Paper #GMD-2024-87 | Model experiment description paper: 'Design, evaluation and future projections of the NARClIM2.0 CORDEX-CMIP6 Australasia regional climate ensemble'

Author Comments (ACs) – Referee 3

Table 3. Anonymous Referee 3 (RC3) Comments

Figure 15: revised version

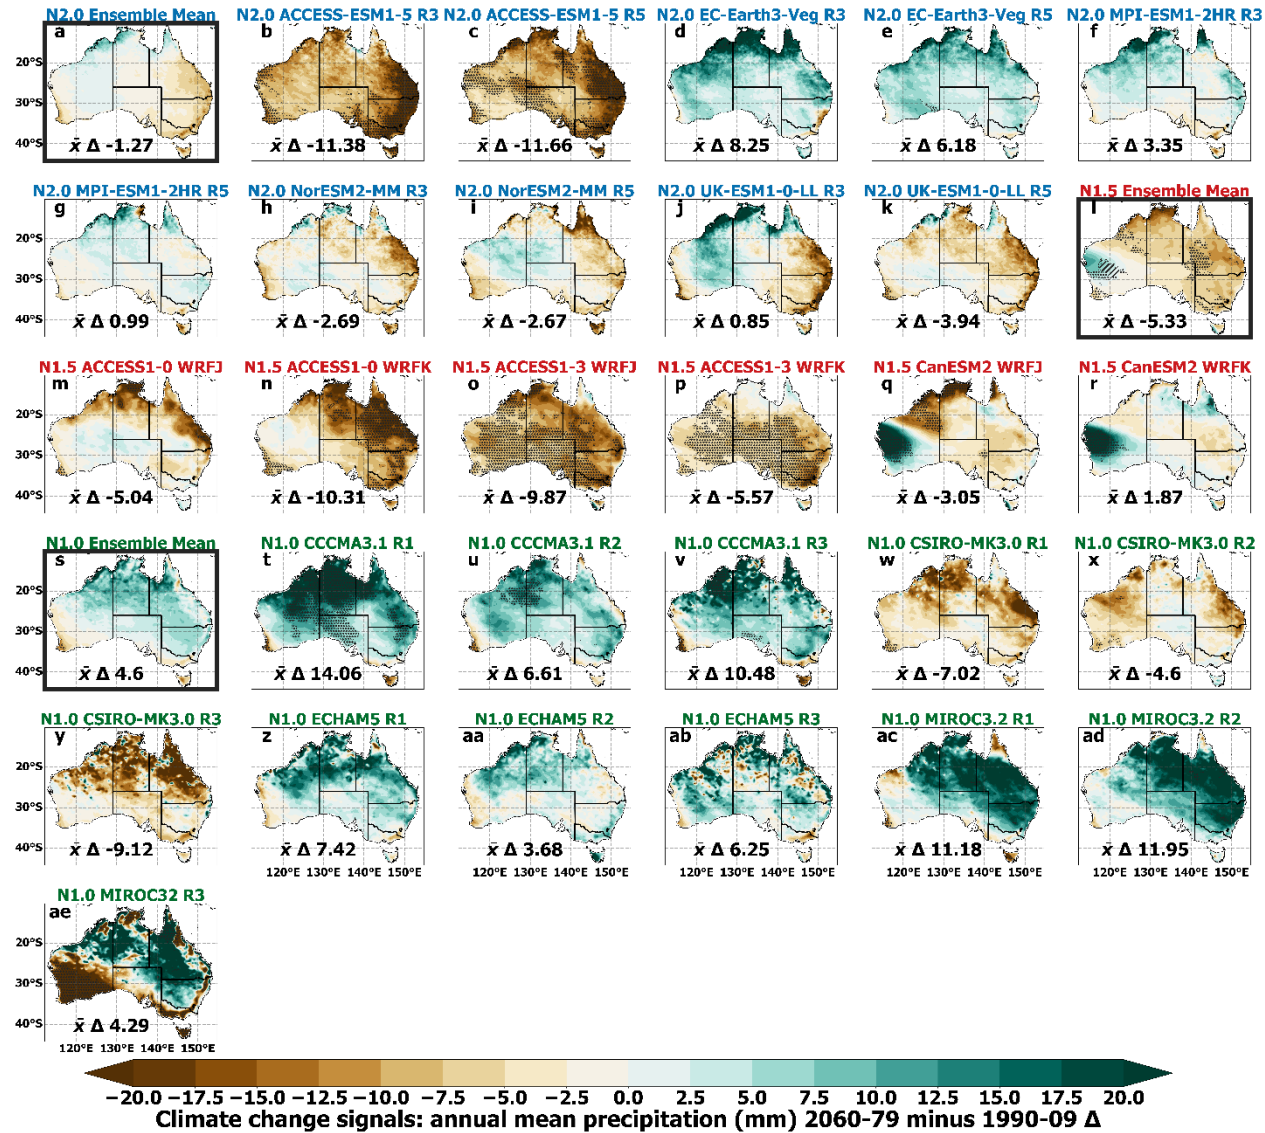
al., (https://gmd.copernicus.org/preprints/gmd-2024-41/gmd-2024-41.pdf) for further details.	
12	Figure 15: there are many subfigures and their titles are not easy to read. Please consider improve the visualization.	Agreed, the original Figure 15 was of insufficient quality (e.g. 300 DPI), so we have increased to 600 DPI and improved clarity of stippling and titles as far as is possible for a figure with 31 individual plot panels.	Figure 15 revised, please see example below this table.
13	Line 777: “with 4 RCMs using BMJ, 2 RCMs using Tiedtke, and 1 using Kain-Fritsch.” Please give the references to the cumulus parameterisations.	This is a good idea – we have included references for all physics used in the study.	References for all physics settings used added into Table 3 in the revised manuscript.
